Ministry of Housing, Communities & Local Government consultation

Future Buildings Standard

Submission from CIBSE

13.04.2021

SUPPORTING EVIDENCE – ITEM B: PRIMARY ENERGY FOLLOWS CARBON FOR ELECTRICITY, AND ENCOURAGES FOSSIL FUELS AGAINST ELECTRICITY

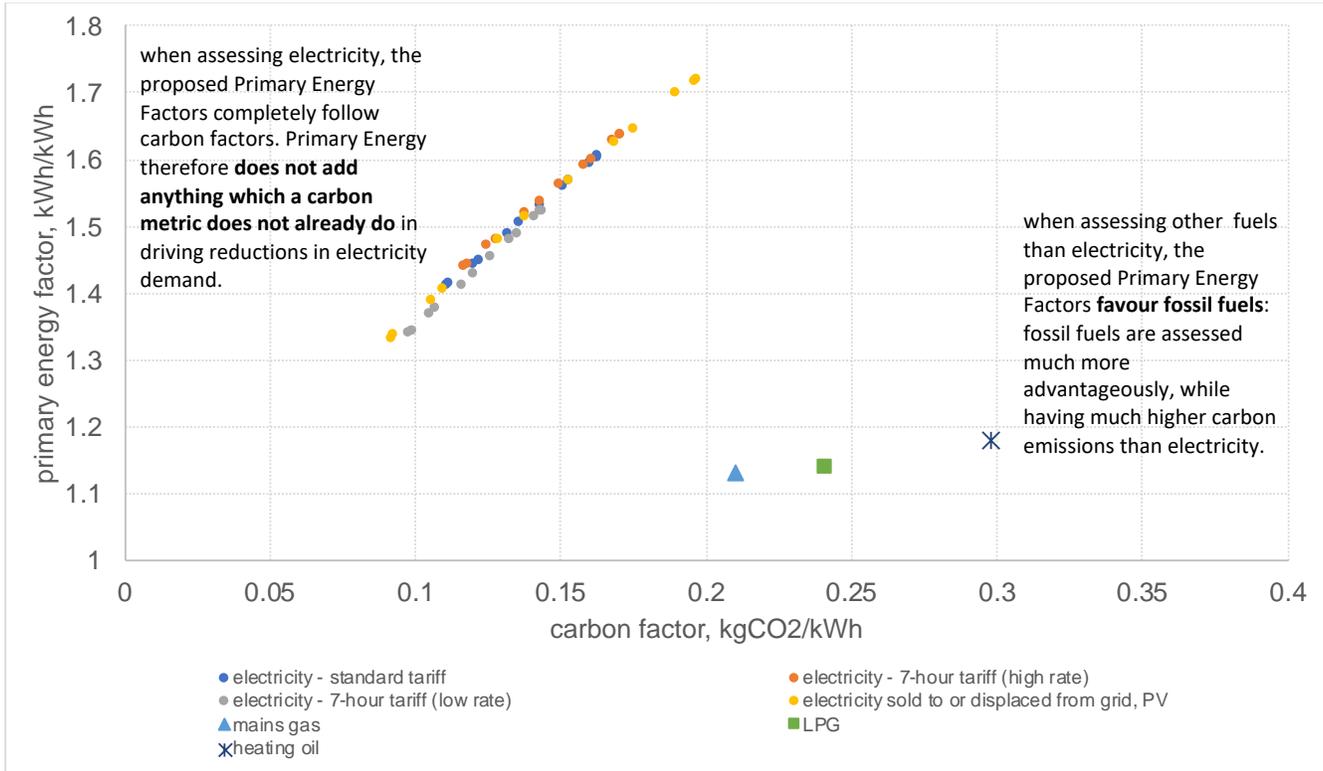
- *“reducing electrical infrastructure needs”*: this is flawed. Our analysis shows that the proposed primary energy factors for electricity are almost exactly correlated with its carbon factors – see graph in Supporting Evidence – Item B. This means that any incentive provided by primary energy as a metric to reduce electricity use at times of high demand is already provided by carbon emissions as a metric: primary energy as a metric, for this purpose, does not add anything that carbon does not already do. Our recommendation: Instead, energy use as a metric would, combined with carbon emissions, provide an added focus on the efficiency of the building itself. It would also, at a given heat demand, encourage heat pumps over direct electric heating, i.e. further reduce demand on the grid.
- *“set an energy performance target which prioritises the energy efficiency of the*

- also as explained in Question 11, the settings of the Primary Energy Factors (PEF), by (rightly) wanting to differentiate between renewable and non-renewable energy sources into the grid, mean that when looking at electricity, primary energy factors do

not add anything to carbon emissions: they are directly correlated – see Supporting Evidence – Item B.
